PJM RTEP – 2014 Window #2 Addendum Proposal Window Problem Statement & Requirements Document

Scope: 2019 N-1-1 Voltage Drop Reliability Criteria

Original Document: January 20, 2015

Impacted Proposals – 12/18/2014 TEAC Webcast Slide 45

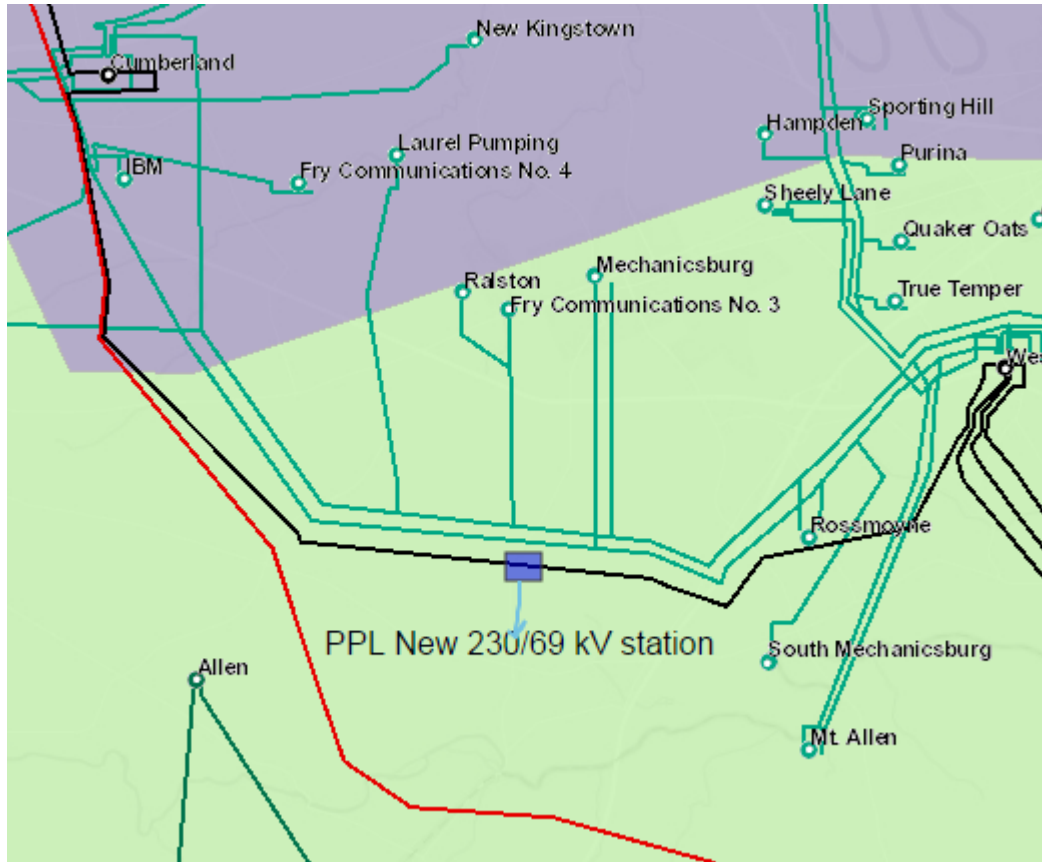
The new topology will include the S0859 upgrade proposed by PPL. PPL is building a new 230/69 kV substation by tapping the Cumberland to West Shore 230 kV circuit. The new station will be tapped on the 230 kV circuit and will be located at approximately 63% of the total distance from Cumberland substation. In addition, a high level depiction of the location of the topology change is below. The image in the high level depiction is produce by PJM based on locational data provided by PPL. The PPL proposed supplemental upgrade is (S0859) to build 230/69 kV station by tapping the Cumberland – West shore 230 kV circuit. The new substation will be located about three miles from Allen station. The PPL upgrade doesn't impact the previous or current analysis result; however it has an impact on the proposed solution.

- Supplemental Upgrade:
- To address a load growth in the Cumberland and West Shore areas.
- Proposed Solution:
 - Build new 230-69 kV Substation between Cumberland and West Shore Substations and terminate Cumberland-West Shore 69 kV lines at the new station. (S0859)
- Estimated Project Cost: \$ 38.5 M
- Projected IS Date: 12/31/2018
